5.3 T220197 PA - Buildings and Works (Construction of a Shed) - 99 Split Rock Road, Beaconsfield Upper

That Council refuse to grant Planning Permit T220197 for Buildings and Works (Construction of a Shed) at CA 18 SEC C Parish of Gembrook, 99 Split Rock Road, Beaconsfield Upper VIC on the following grounds:

APPLICATION NO.:	T220197
APPLICANT:	Sonya Boloski Lakeside Building Consultants
LAND:	99 Split Rock Road, Beaconsfield Upper VIC 3808 CA 18 SEC C Parish of Gembrook Assess: 1788450300
PROPOSAL:	Buildings and Works (Construction of a Shed)
PLANNING CONTROLS:	Green Wedge A Zone – Schedule 1 Bushfire Management Overlay Environmental Significance Overlay – Schedule 1

NOTIFICATION & OBJECTIONS:	The application has been advertised pursuant to Section 52 of the Planning and Environment Act 1987, by sending notices to the owners and occupiers of adjoining land and placing one (1) sign at the front of the site. Zero (0) objections were received
KEY PLANNING CONSIDERATIONS:	Visual impact to the rural character of the area Inappropriate siting
RECOMMENDATION:	Refusal

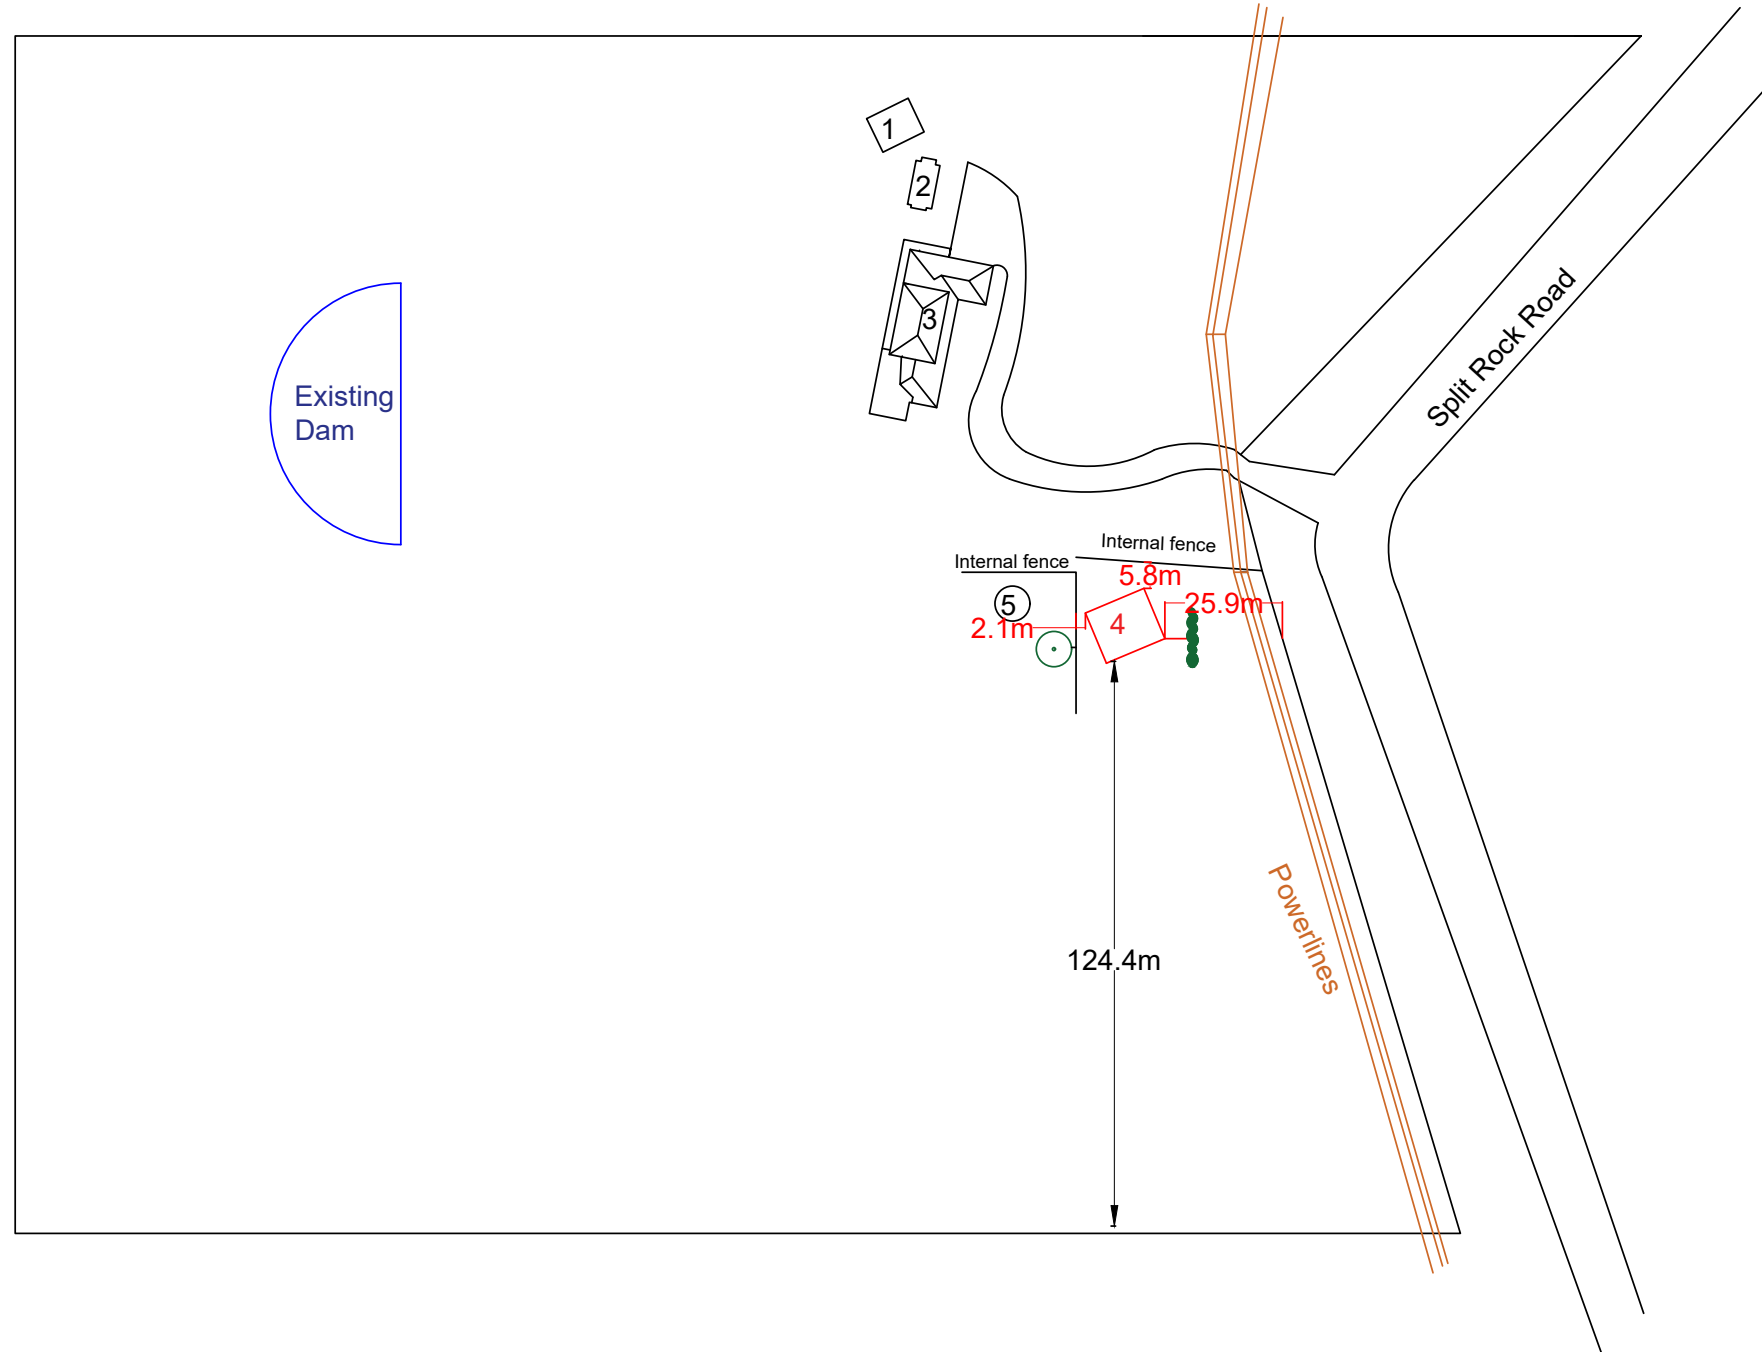
siting that enables such a level surface, with the land leveling out upon this ridge. The size of the proposed shed is not insignificant, with a proposed floor area of 168sqm. While the provided site plan is not exceedingly clear, the view from the east and down Split Rock Road will be that of the eastern side of the structure, mitigating any possible reduction of visual impact the “barn style” might provide. Paired with the maximum height of 6.2m at the ridge, the shed will have a significant impact on views.

The impact on view lines from this location is deemed unacceptable. It is not concluded that suitable effort was made to pursue an alternative siting. While on balance other locations may have required more earthworks, this would result in a better overall outcome. Council made efforts to facilitate a relocation, preferably within the existing cluster of buildings further down the slope and not highly visible from the road.

The proposal to plant a hedge to obscure the structure further from the road is lacking and fails to address the key issue, this being that the structure will have an impact on the landscape character of the area and inappropriately impact on view lines.

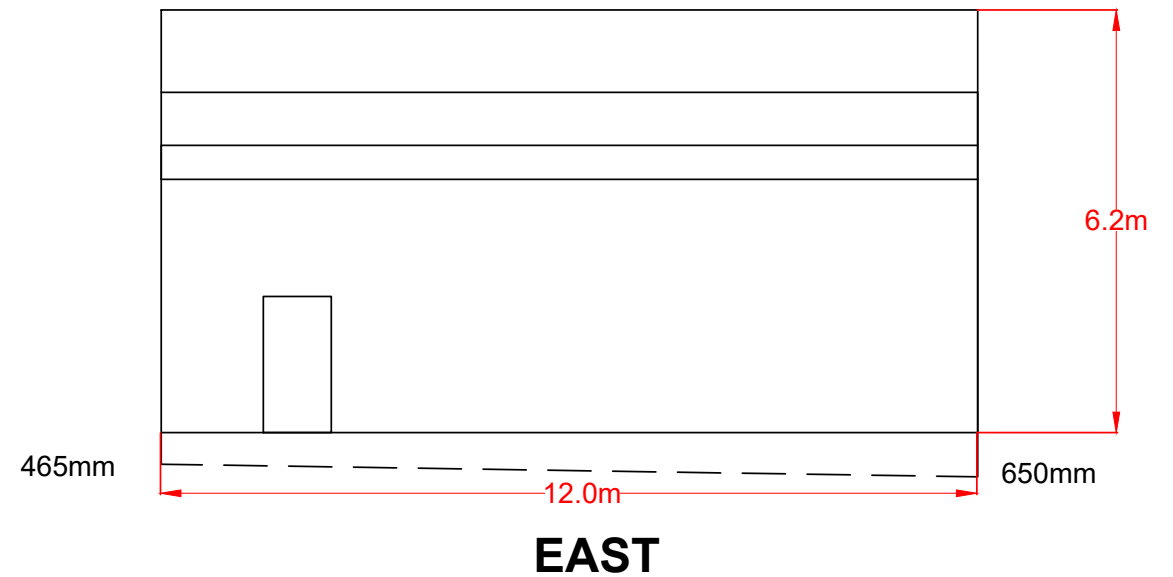
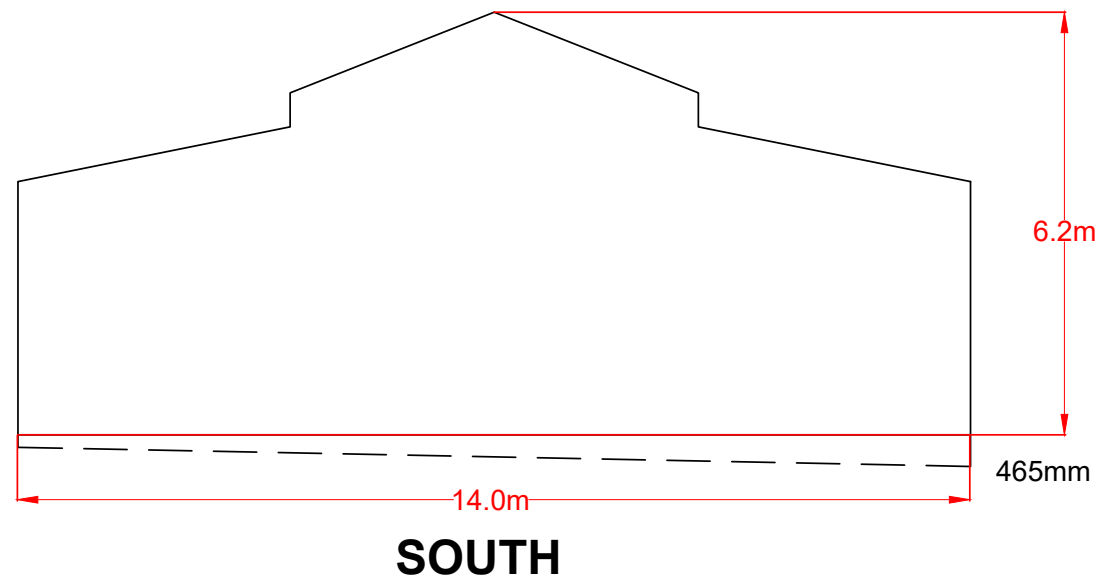
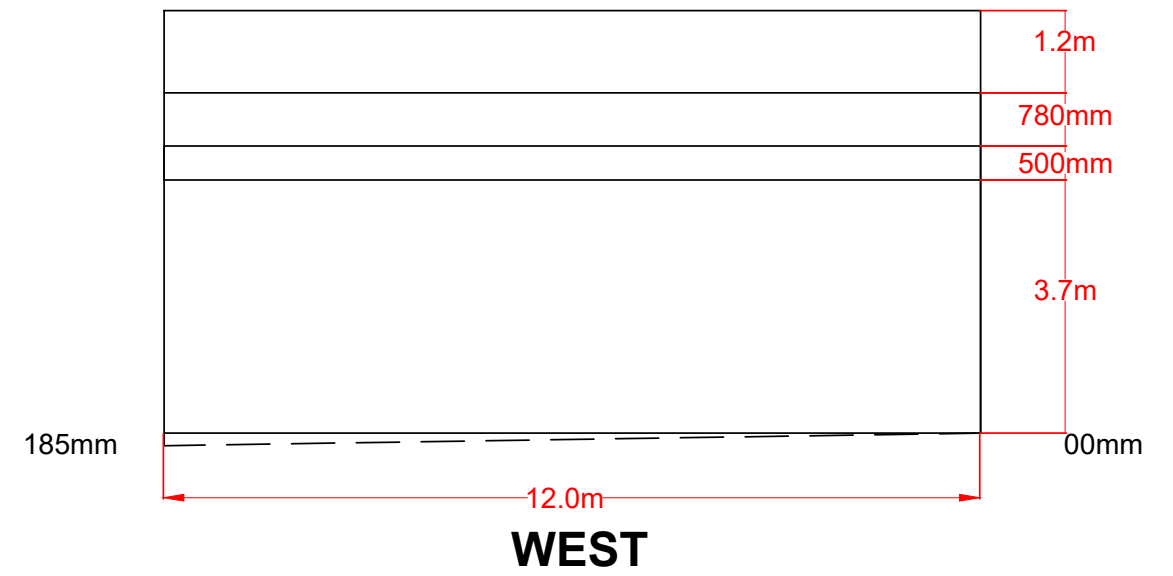
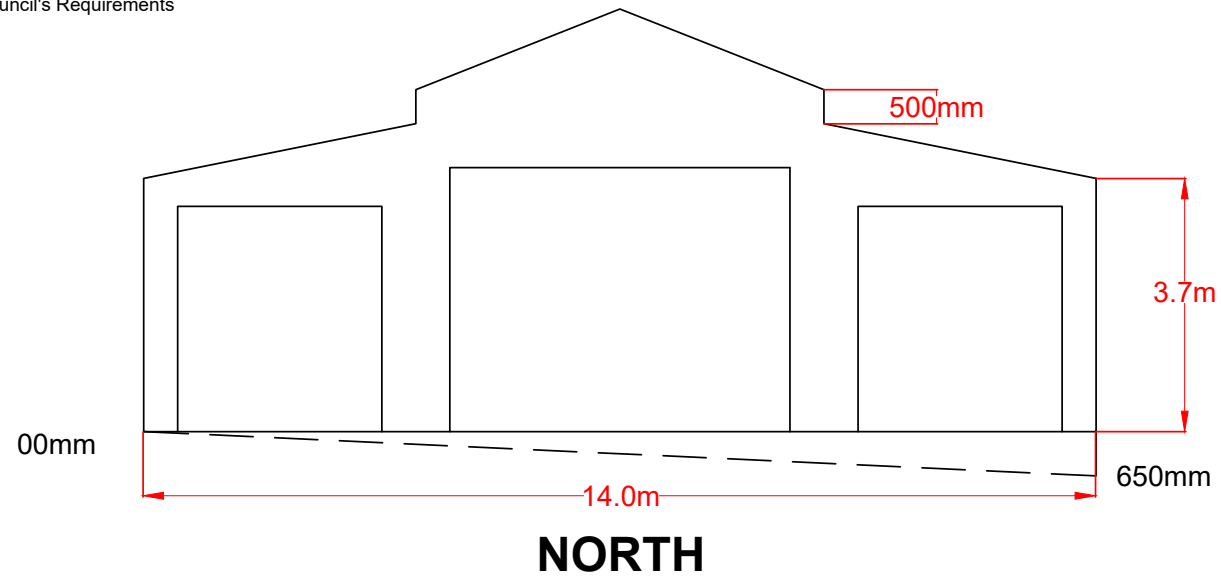
The shed is to have a wall height of 3.7m, a height of 4.2m to the bottom of the bump-out, 4.98m to the top of the bump-out wall, and a total height of roughly 6.2m to the middle ridge. It is to be constructed entirely of Colorbond steel, with the chosen colour being Woodland Grey.
